**From:** Jayne Macdonald <jmacdonald@mactodd.co.nz>  
**Sent:** Friday, 4 March 2022 10:41 am  
**To:** Ann Rodgers  
**Subject:** FW: PC14 - Shannon Farm  
**Attachments:** ASLA annotated Nov 24 revised SP .pdf

Further to our Zoom meeting last week, Anne Steven produced the attached marked up structure plan in response to the plan prepared by Tony Milne. Referring to the exchange below, you will see that matters related to the Structure Plan are pretty much resolved.

ASLA RESPONSE TO REVISED SP (NOV. 19 2021) supported by Rev 3 of Indicative layout Plan 24/11/21.

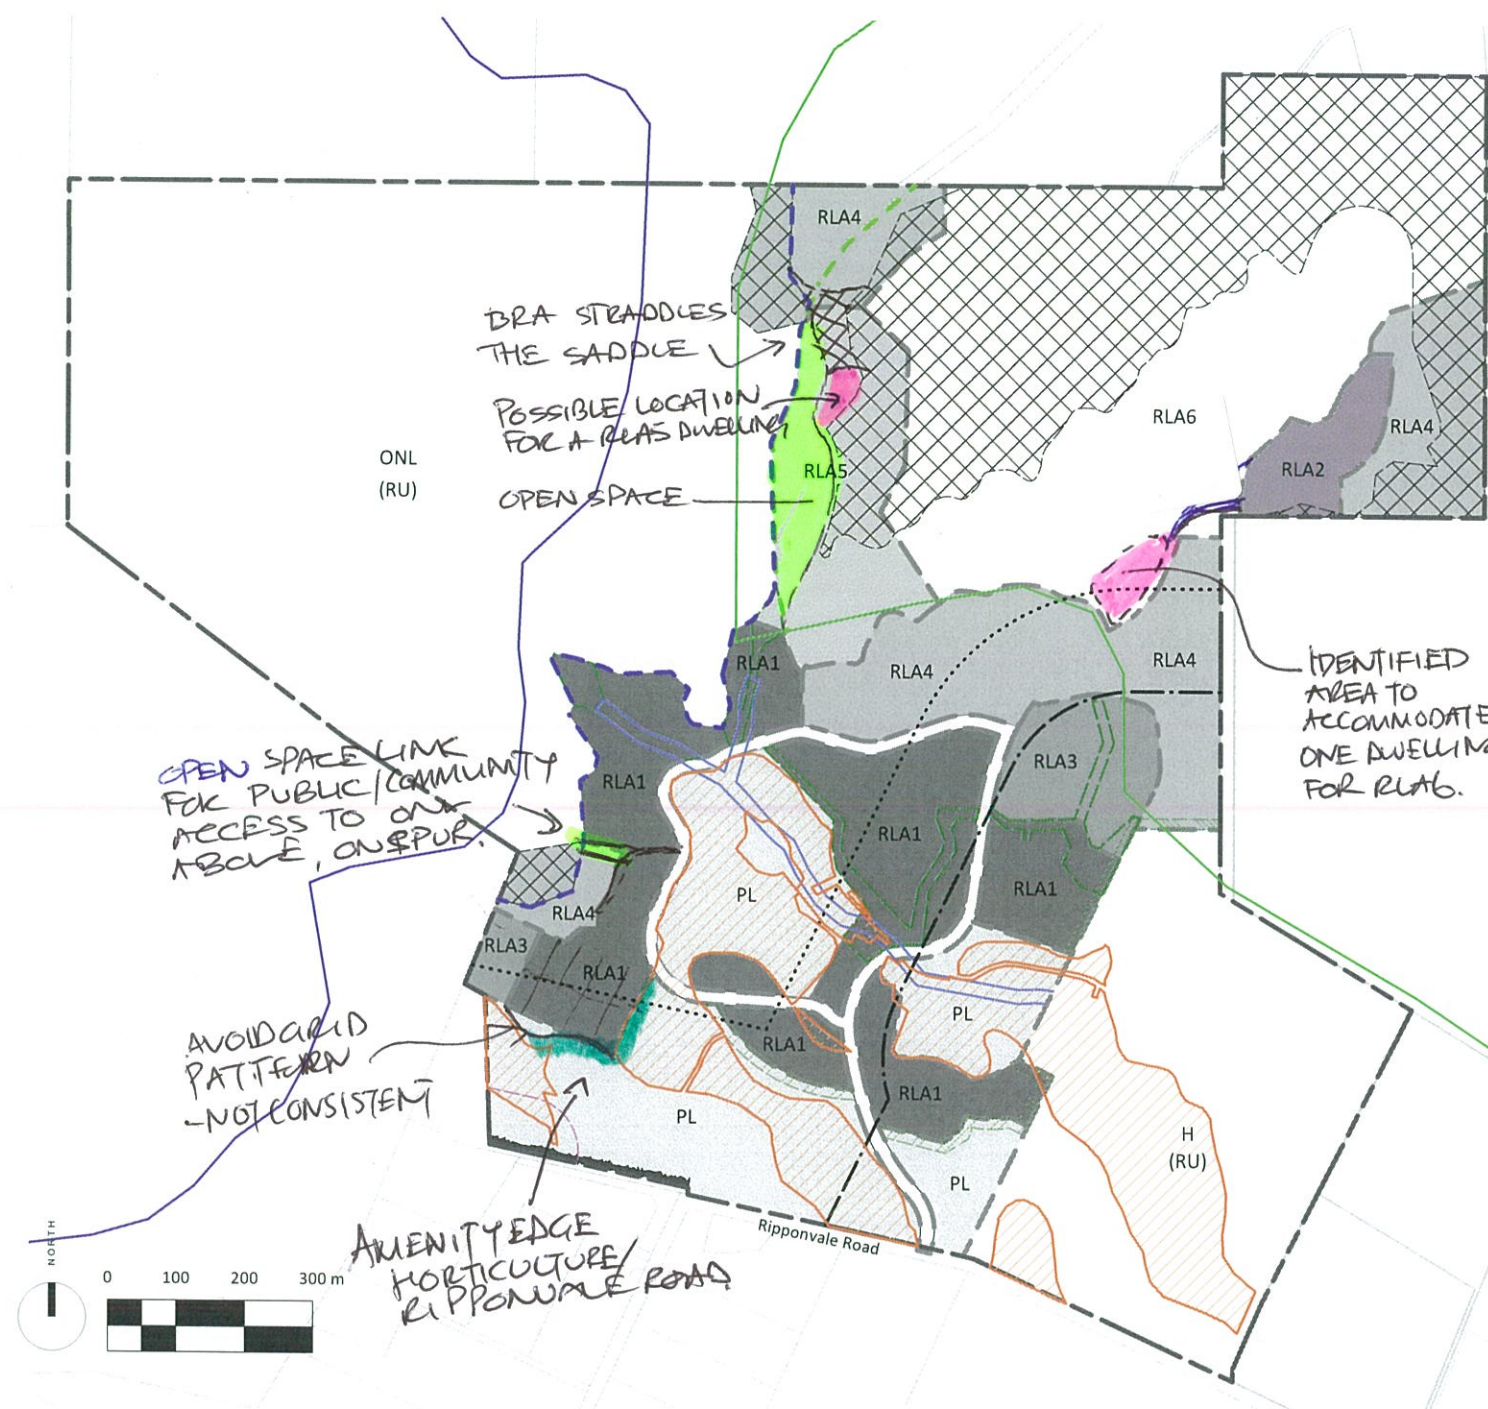
1. It is really good the bulk of the SAL is proposed for single lot ownership and management. The No Build area still omits the mid to lower slopes within the SAL which are highly visible and sensitive, and seamless with the upper slopes.

- (i) to bring the BRA right down to cover most of this area excluding a small area where a future dwelling may go; or
- (ii) (ii) leave the BRA as it is but identify a specific area to locate the future building platform and single dwelling/farmstead within. I have identified the only suitable area (in my opinion) on the attached plan.

2. The No Build area should straddle the saddle at the top of the gully between ONL and SAL (refer attached plan). Built form is not appropriate on or close to the saddle in my opinion. There is a possible building platform location area for RLA5 that could be cut out from the BRA in a slight indent near the top of the gully (refer attached plan) - providing it is well screened from view including night lighting. The future road-mitigating tree planting in the gully that is agreed could be utilised to ensure this outcome.

3. The area below the indicative road in the gully should be marked as open space (for the future tree planting), as per your indicative layout plan.

4. The RLA1 and RLA2 roll together is supported. However a uniformity of Lot size and homogenising of the landscape (eg, through earthworks) needs to be strictly avoided. The preference is for a genuine range of lot sizes from 1500 to 3000m2 with the lot size averaging 2000m2 (noting that the calculation of this would presumably need to exclude any large common lots in order to achieve the intended lot size diversity) . The design of the lots should closely reflect and express the natural topography and other ambient landscape characteristics. I appreciate the layout provided is only indicative however it illustrates a high degree of uniformity. To this end, we discussed Policy 4.4.18 and matters of control in the subdivision rule picking up some of this wording. It would be interesting to know what the lot size range is in the indicative layout if that level of information is available. I also recommend avoiding any potential for grid layout (southwest corner) as this is inconsistent with the overall pattern.

5. I recommend retaining an open space/access link between the basin floor and the ONL area, up the small spur in the southwest through the RLA1 area where you have indicated a service road. This gives easy access to the southwest ridge in the ONL and assists in keeping buildings off the spur.

6. Finally, we noted there is no amenity tree planting along the visually exposed south/southeast edge of RLA1 in the southwest corner. This should be included in the SP.

NEED TO ENSURE THERE IS INDEED A RANGE OF LOT SIZES EXPRESSING AMBIENT LANDSCAPE CHARACTER + TOPOGRAPHY. (AVOID UNIFORM LOT SIZES)

1. I believe we should leave the BRA as shown on the revised Structure Plan, however as you suggest, identify a specific area to locate the future building platform within. To that effect I agree with the location you have identified. We will adopt that on the Structure Plan.

2. Agree regarding adopting the no build to straddle the saddle as you have shown. I also agree with regard to identifying a building platform within this area of RLA5 in the location you have shown. The Structure Plan will be updated to reflect this.

3. Agree with the open space suggestion. Structure Plan will be updated to reflect this.
4. In regard to your comments at 4, I understand these. I suggest the best way forward is for this to be captured in the matters of control in the subdivision rule. I have reviewed these and I believe some of your comments are currently caught (in part) by assessment matter (8). Also note, that assessment matter (3) already addresses extent of earthworks, as follows:

1. Agree with the open space/access link. Structure Plan will be updated to reflect this.
2. I don't agree with the need for an amenity edge tree along the south/southeast edge of RLA1 in the southwest corner. I don't believe this is visually exposed from either leg of Ripponvale Road, due to the angle and distance it will be viewed from. There is also the proposed mitigation planting along the Rockburn boundary that provides additional screening from the north south leg of Ripponvale Road.
